May 14, 2020 Planning Commission Meeting

337 W 7th Ave Packet (page 2)

SEPTA Station Packet (41)

RE: MCPC #20-0048-001
Plan Name: 331 7th Avenue
3 lots/ 3 dwelling units / 0.26 acres
Situate: 7th Avenue (south)/ Wood St (west)

DRAWING TITLE :
EROSION AND SEDIMENT CONTROL PLAN

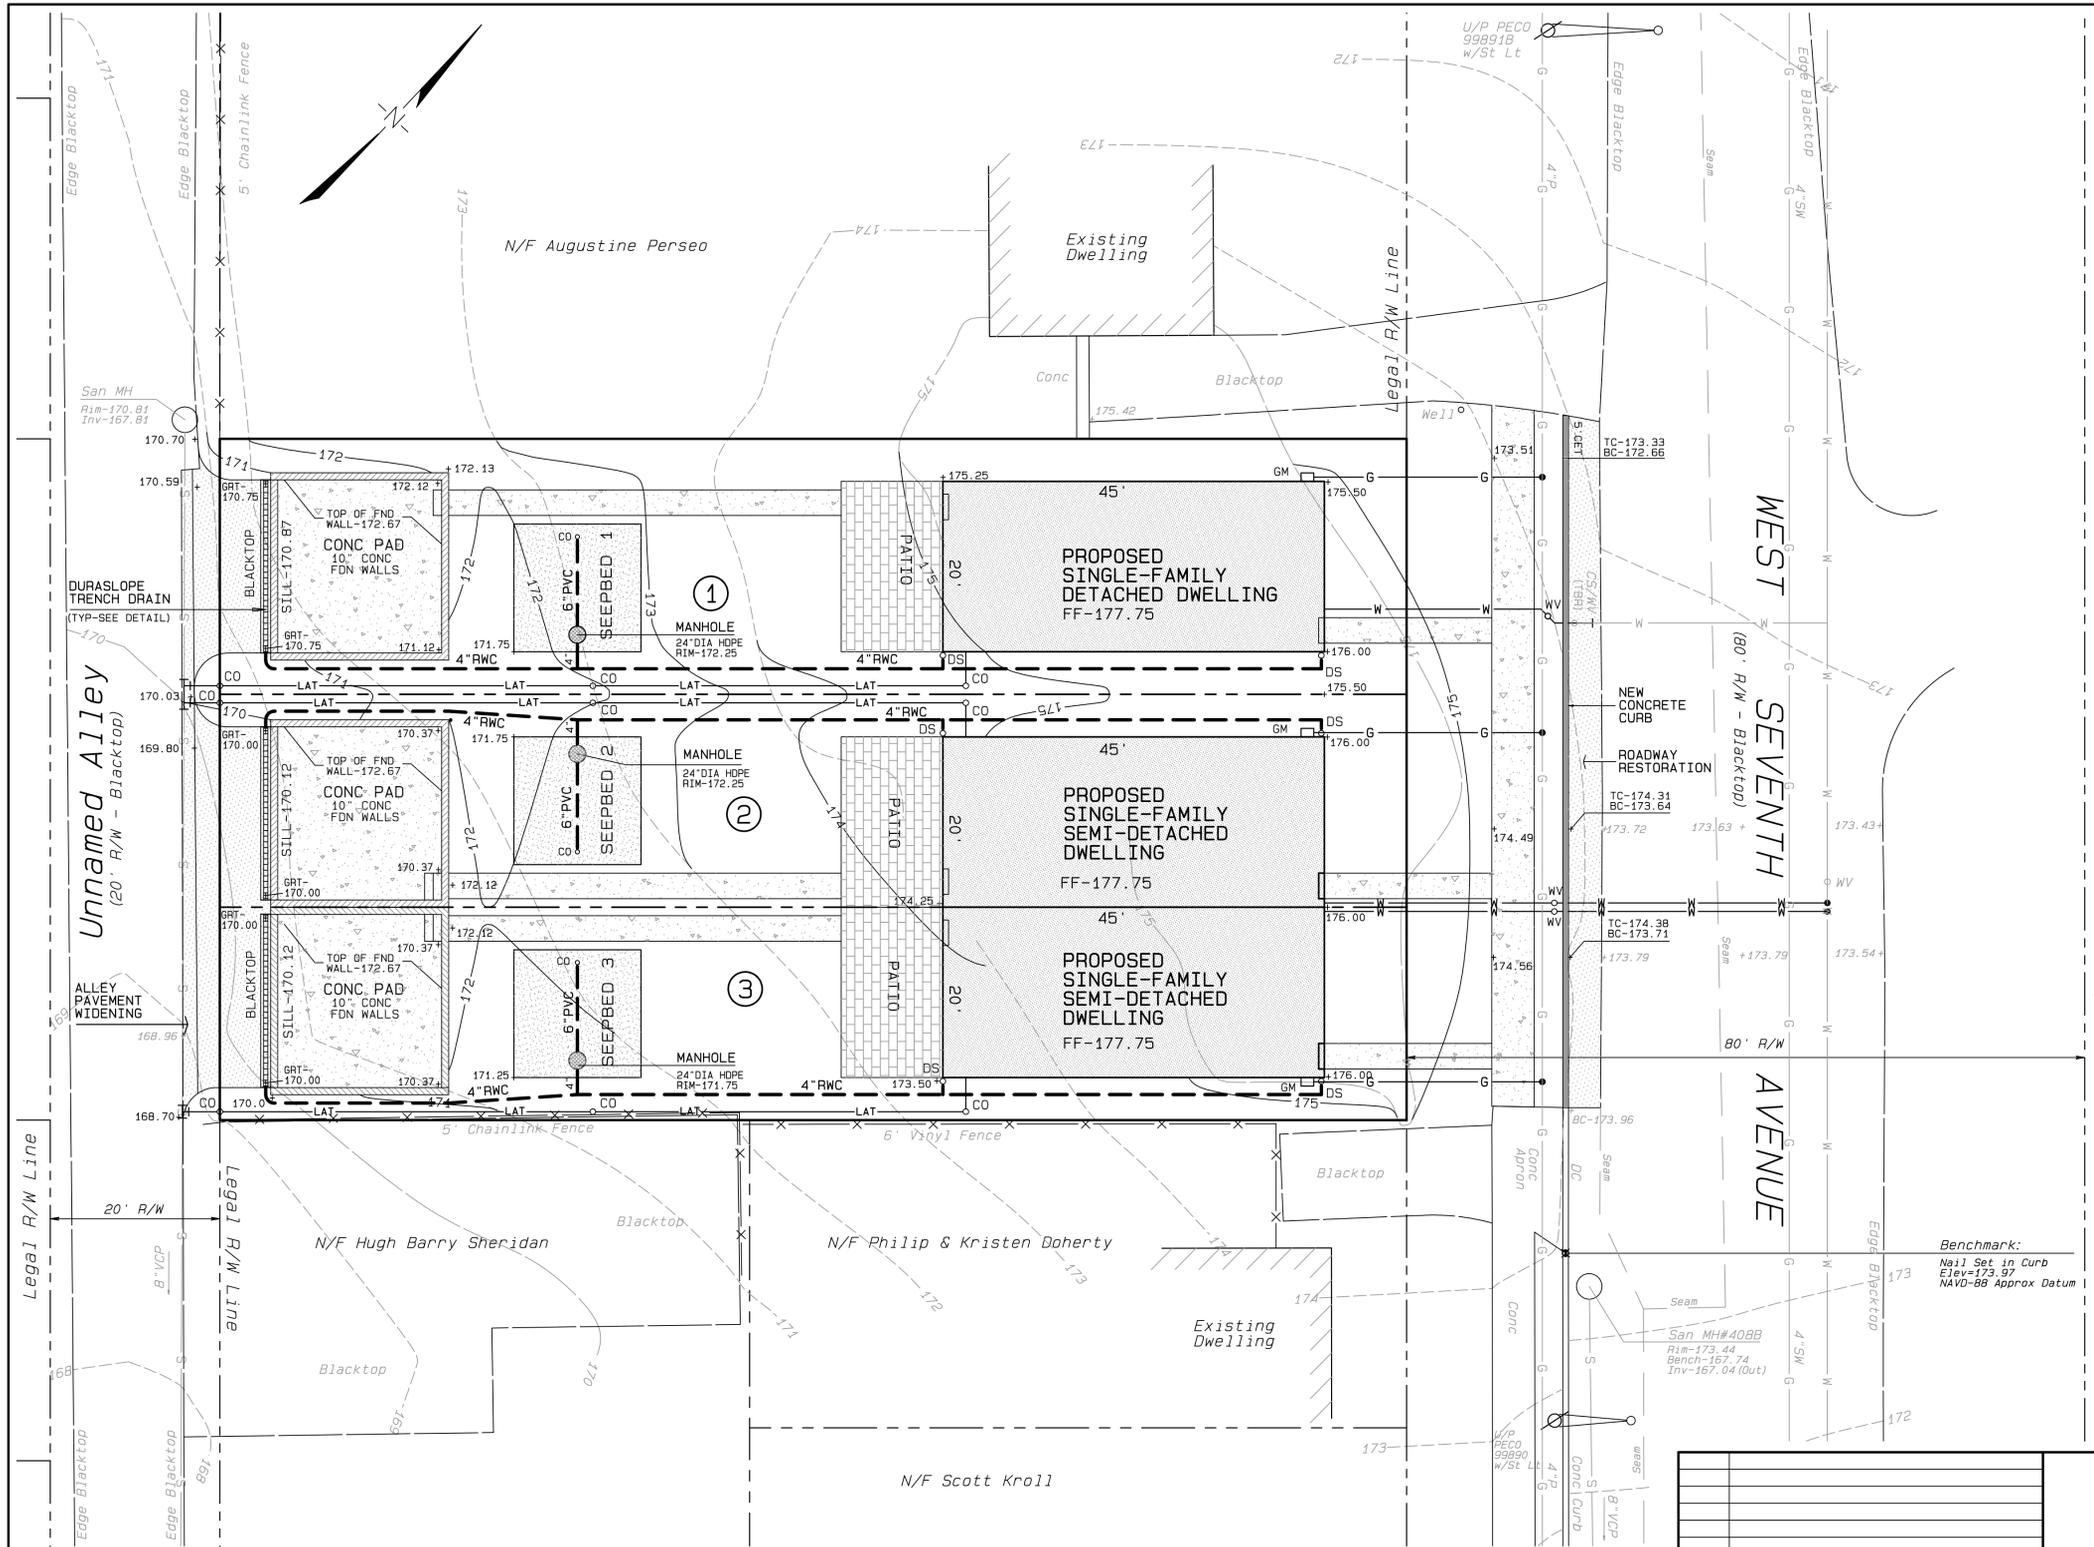
9. §22-412 – A note shall be added to the plans indicating that all proposed utilities shall be installed underground.
10. §22-417 – Information shall be provided on the Erosion and Sediment Control Plan, Sheet 3, to indicate how the seepage beds will be protected from sedimentation and compaction during the construction, such as orange construction fencing.

DRAWING TITLE :
POST-CONSTRUCTION STORMWATER MANAGEMENT PLAN

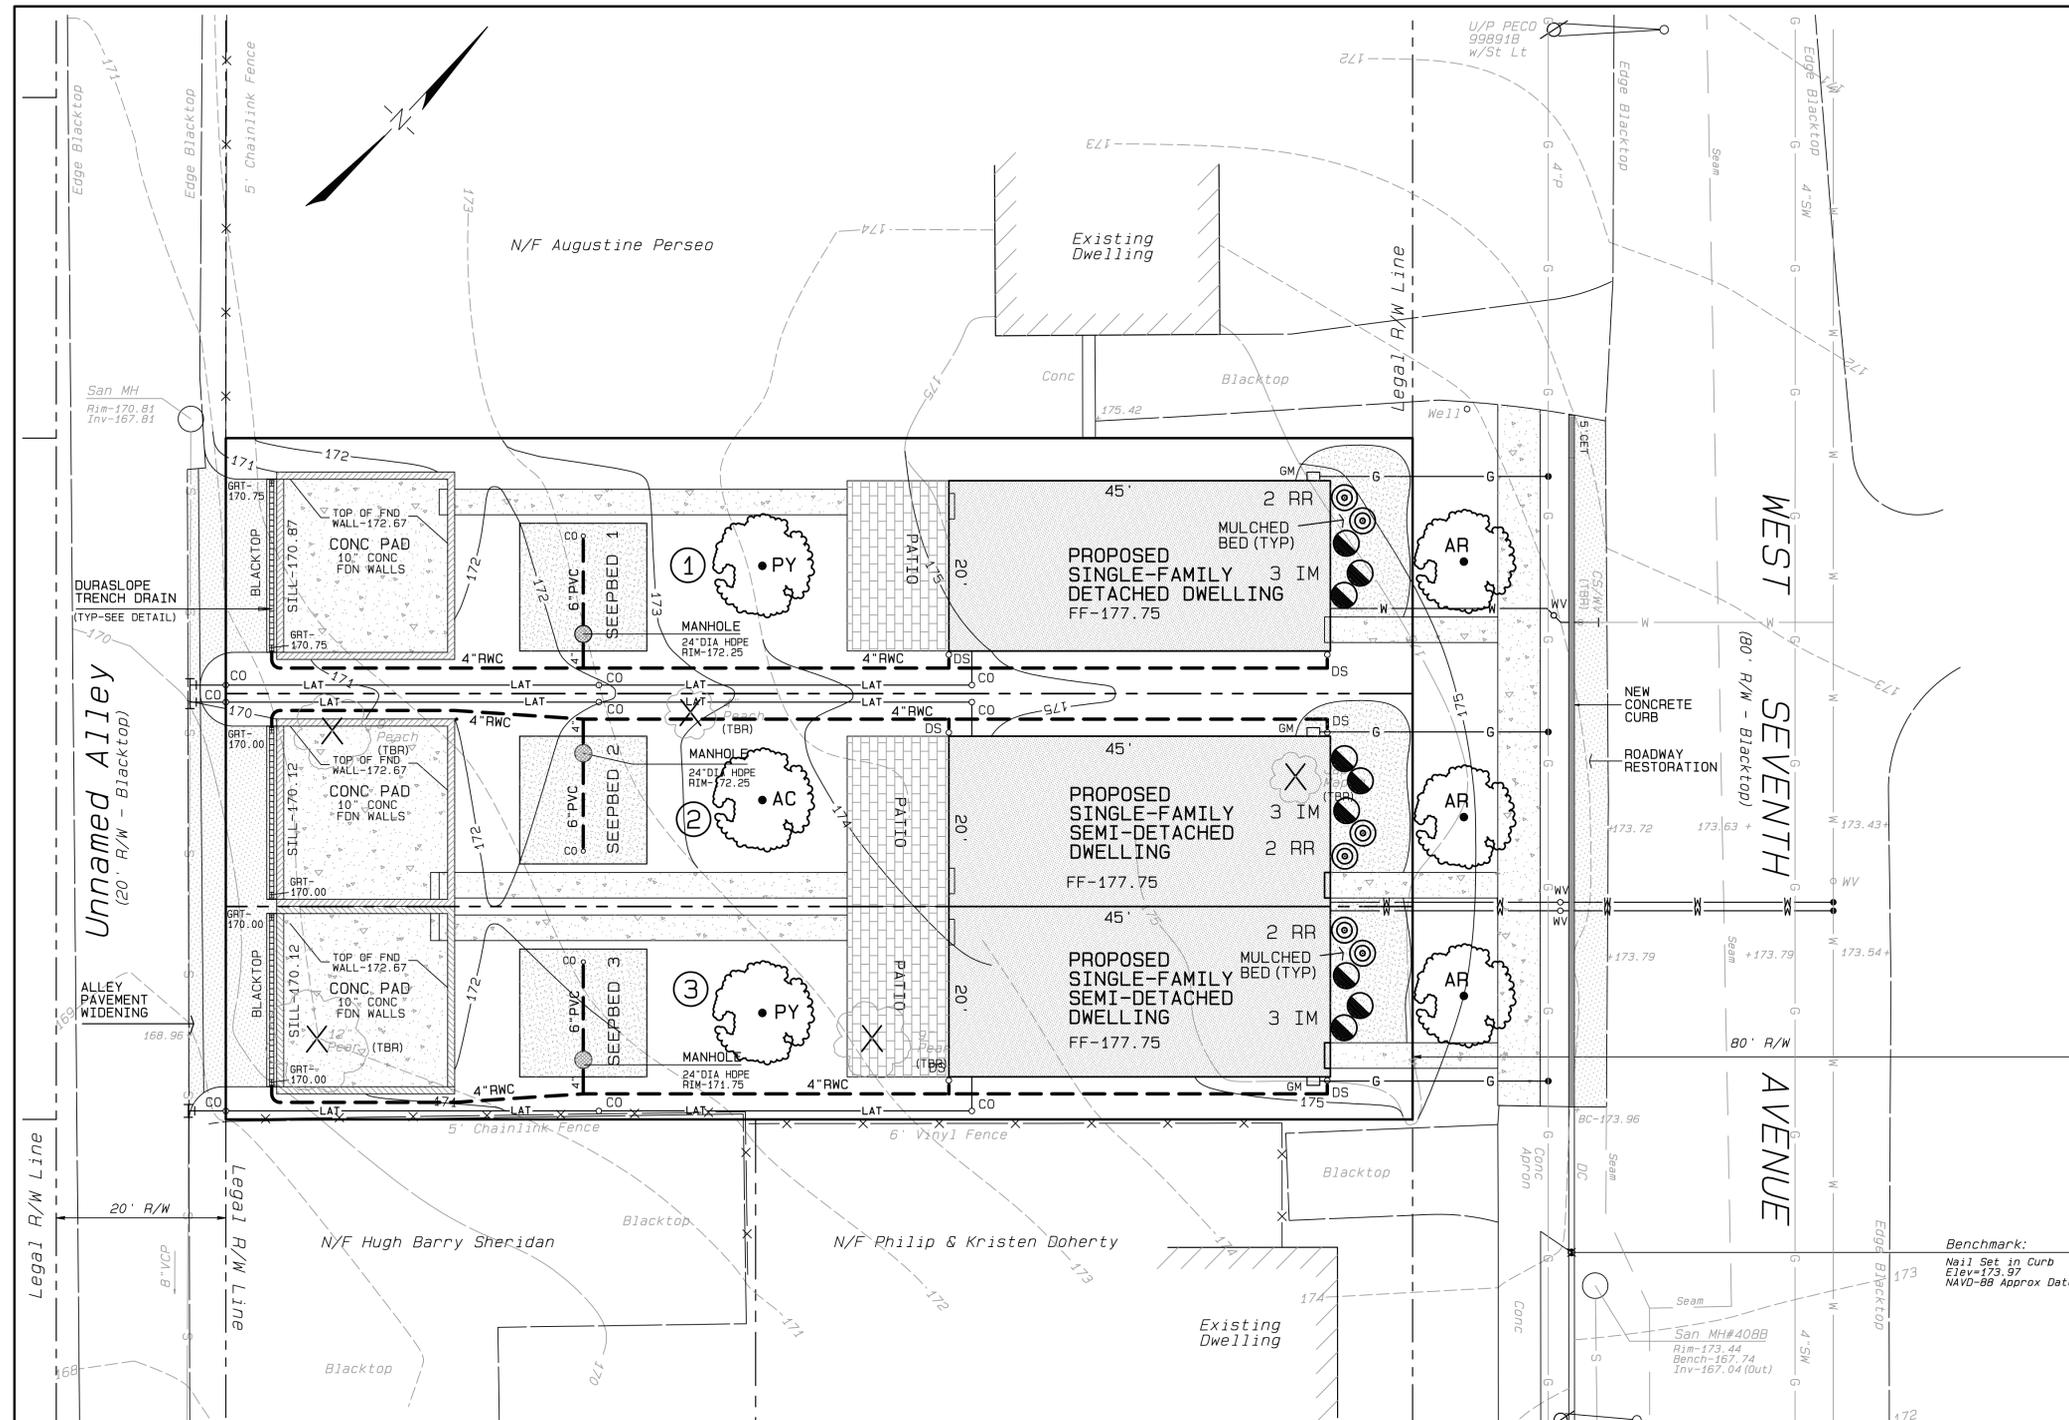
4. §22-409 – We offer the following comments with respect to the grading proposed on the Post-Construction Stormwater Management Plan, Sheet 5:
 - a. Additional spot elevations shall be added to the walkways, including along the site frontage, the rear walkways, and at the tie-ins to the existing driveways, and to confirm maximum two percent cross slopes are provided.

- b. Top and bottom of curb elevations shall be added at the proposed taper and tie-in points, including at the existing depressed curb located south of the site.

1 SITE IMPROVEMENTS PLAN
C400 SCALE: 1"=20'
FILE: REF: -

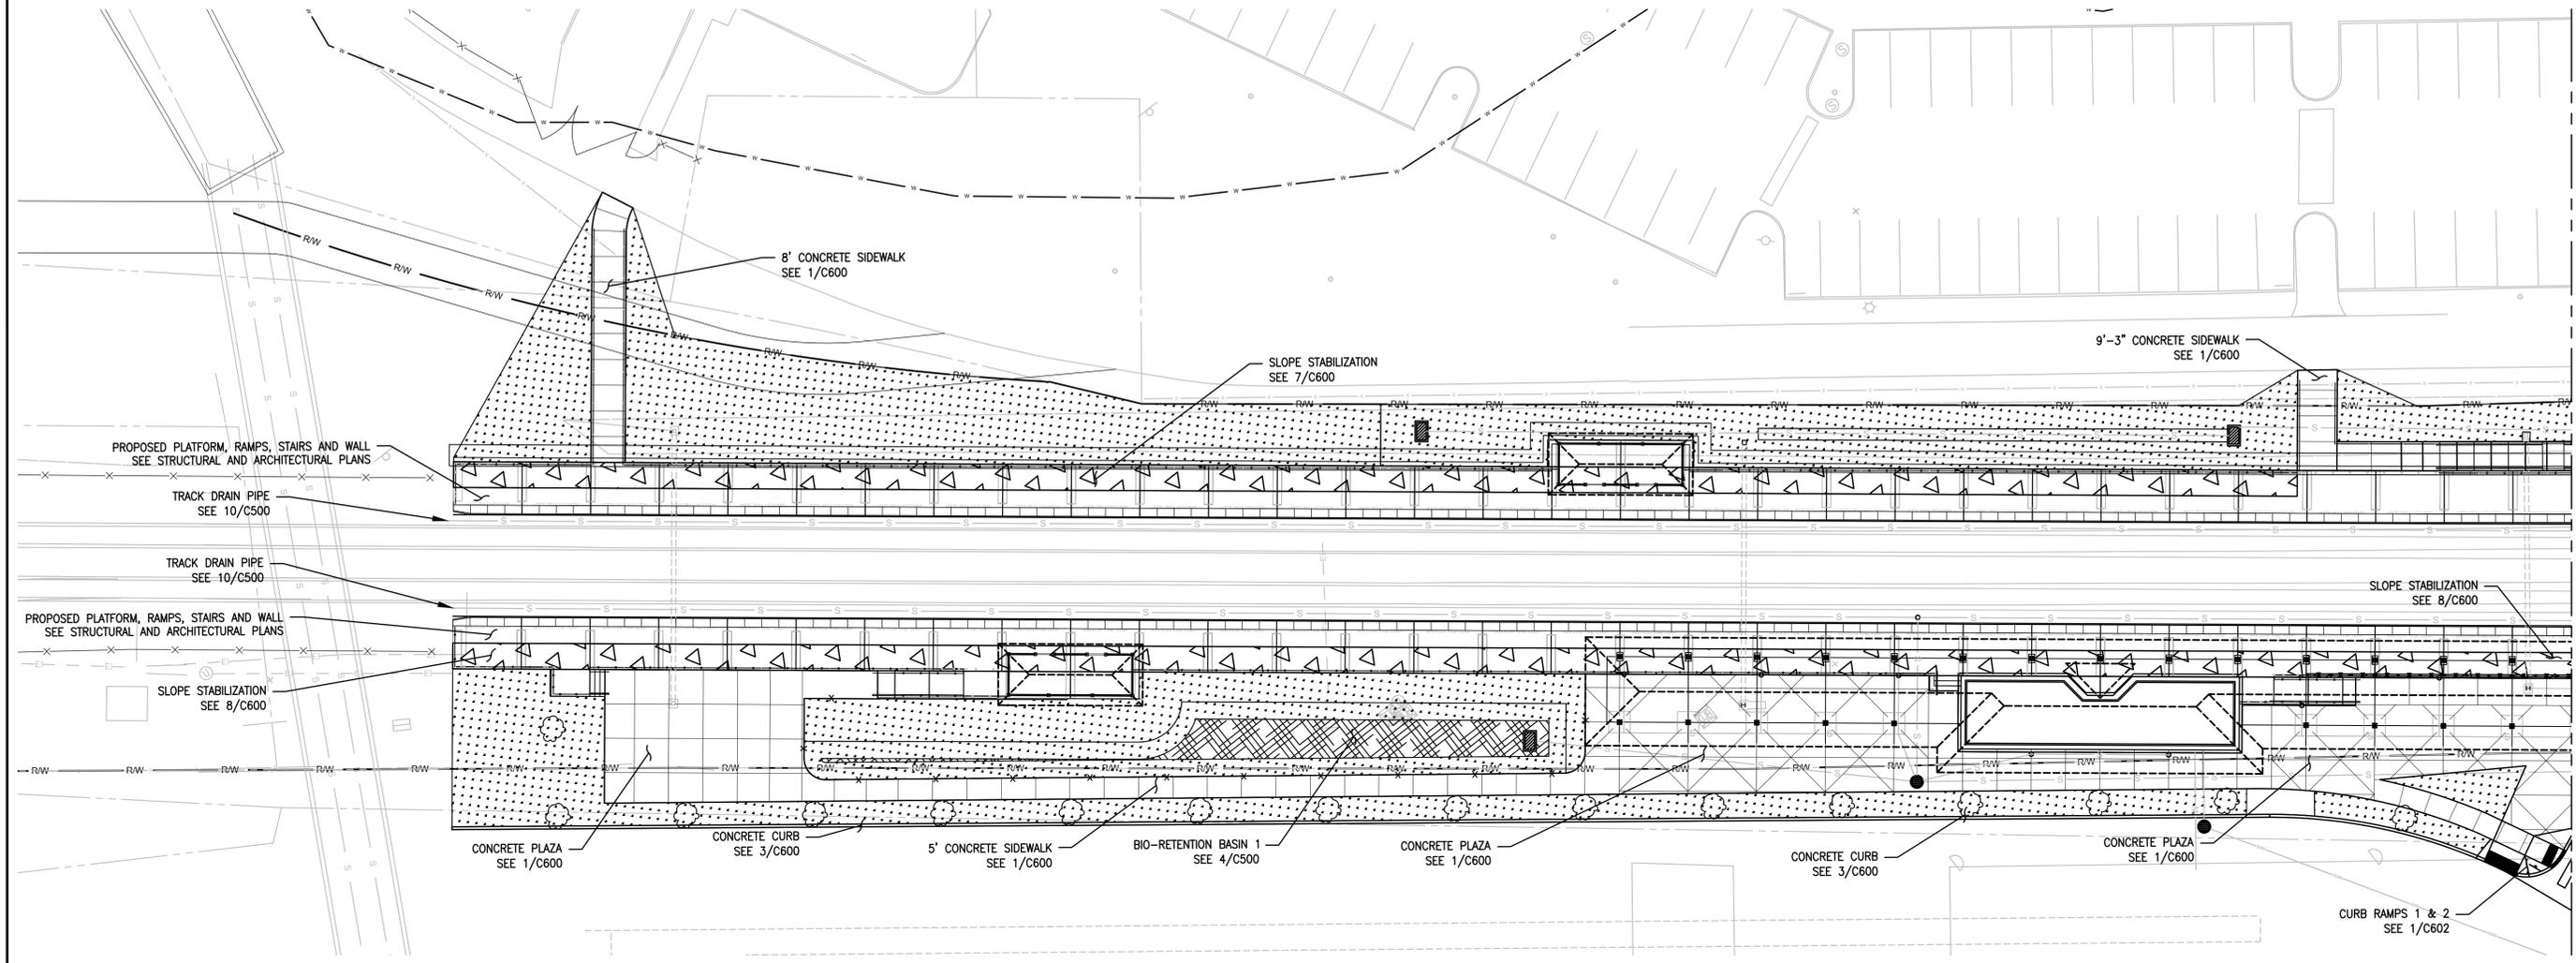
1. Sheet C401 entitled "Site Improvements Plan – 1" and dated January 28, 2020 indicates that a storm sewer manhole would be located in the middle of the SRT at the proposed road crossing. In accordance with AASHTO guidelines, we would like the manhole to be moved to a location outside of the trail corridor in order to prevent slipping accidents by trail users as well as to prevent trail closures when work needs to be performed at the manhole location. We understand that the project engineer is investigating how to achieve this standard.
